DDS- Planning & Zoning: Plan Review Application

Special Permit Submission

**PKV, LLC
 PARKVILLE MARKET
 1390 PARK ST. BUILDING
 ALTERATIONS
 1390 Park St. Hartford, Ct. 06106**

drawing title
**LOWER & UPPER LEVEL
FLOOR PLAN**

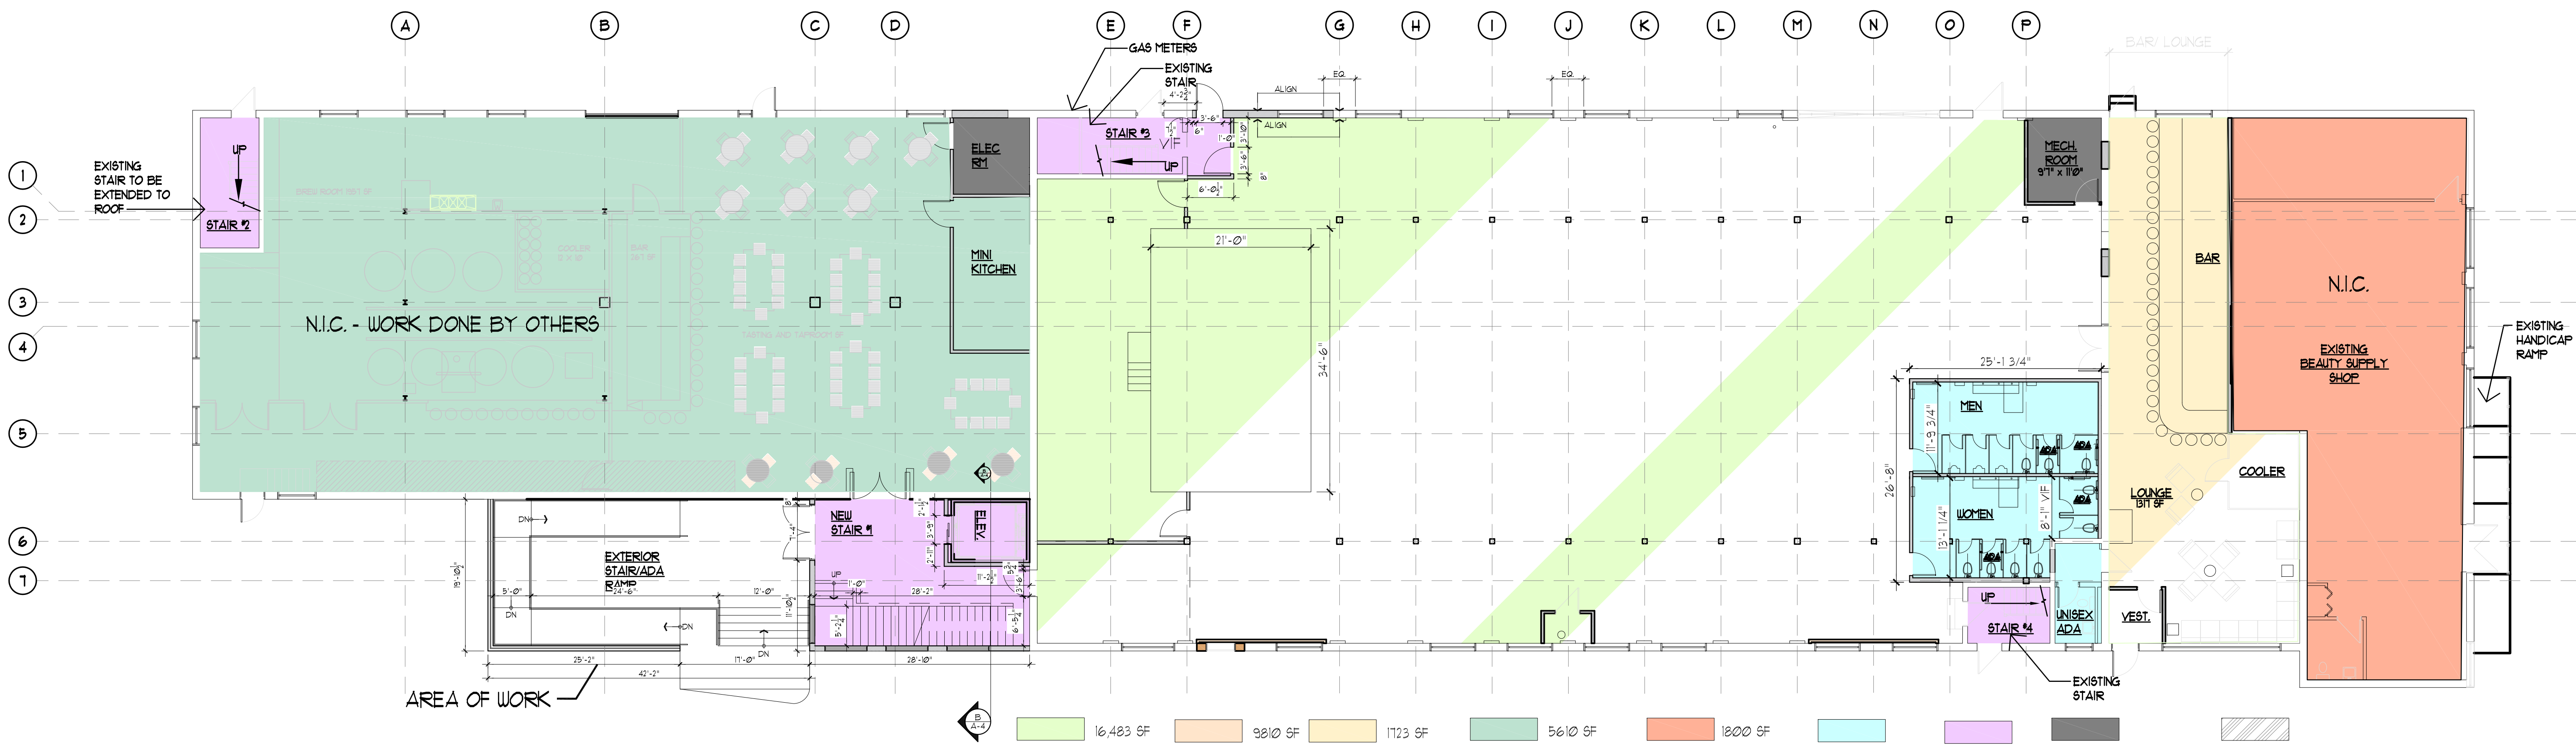
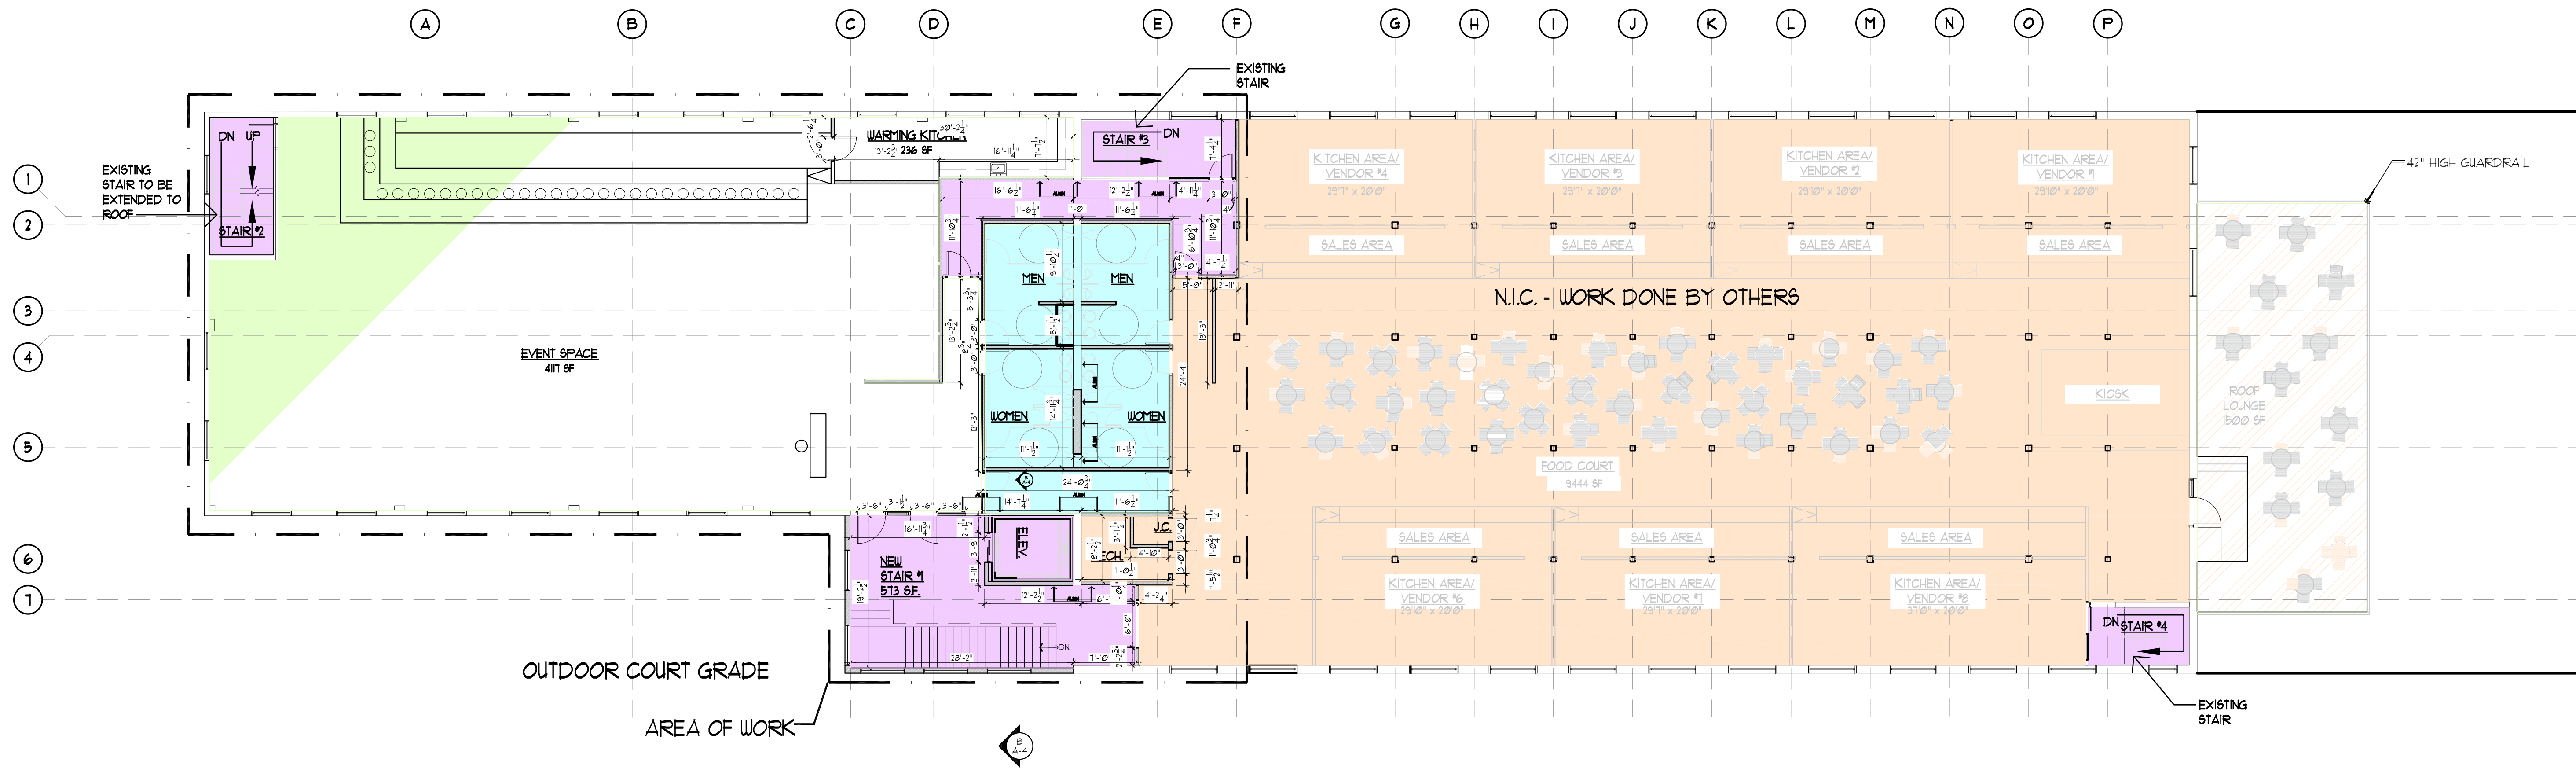
'Food is required to be served. – Please confirm how food will be provided at all times either through a menu or confirmation that the food vendors in the market will be open and accessible to patrons of the entertainment venue.'

Please confirm hours of operation of the Entertainment Assembly and Drinking Place use.

Food will be served at all times within the space either through a catering partner with a catering food license or through the restaurant Operators within the Market. The menu will depend on the event format, but the menus within the Market cover a wide range of appetizers, full meals and desserts, including; tacos, pizza, sandwiches, pasta, ice cream, etc. Our catering partners offer a full gamut of dining options from passed appetizer to full sit down meals.

This space will primarily be in operation for the following:

- During private events, scheduled through our events team in accordance with our current property hours of operation (listed below)
- Additional seating for market patrons during colder months when our patio is closed. The Operating hours in this use case will likely be on Friday evenings, Saturdays and Sundays, when our traffic is highest.
- Entertainment events scheduled by our Events team, within the current Market operating hours.
- Current Market Operating Hours:
 - Monday: 11AM - 8PM
 - Tuesday :11AM - 10PM
 - Wednesday: 11AM - 11PM
 - Thursday: 11AM - 11PM
 - Friday: 11AM - 12AM
 - Saturday: 11AM - 12AM
 - Sunday: 11AM - 8PM

The small outdoor dining area above the first floor of 1390 will be only used for the adjacent food vendors during Market Operating hours.

The Roof Top Lounge on the north end will be used only when the room below is rented for events and will close when the event is over.

The lower level dining hall, see below, will be the first part of this expansion before the circulation tower construction starts and leads way to the upper level projects. This room will keep the existing stair, maintain ADA entrance through the bar entry and have additional bathrooms built. A stage will come later, sized for what the market can sustain. Currently, the hall will start with a temporary platform for ambient music as part of the dining hall experience.
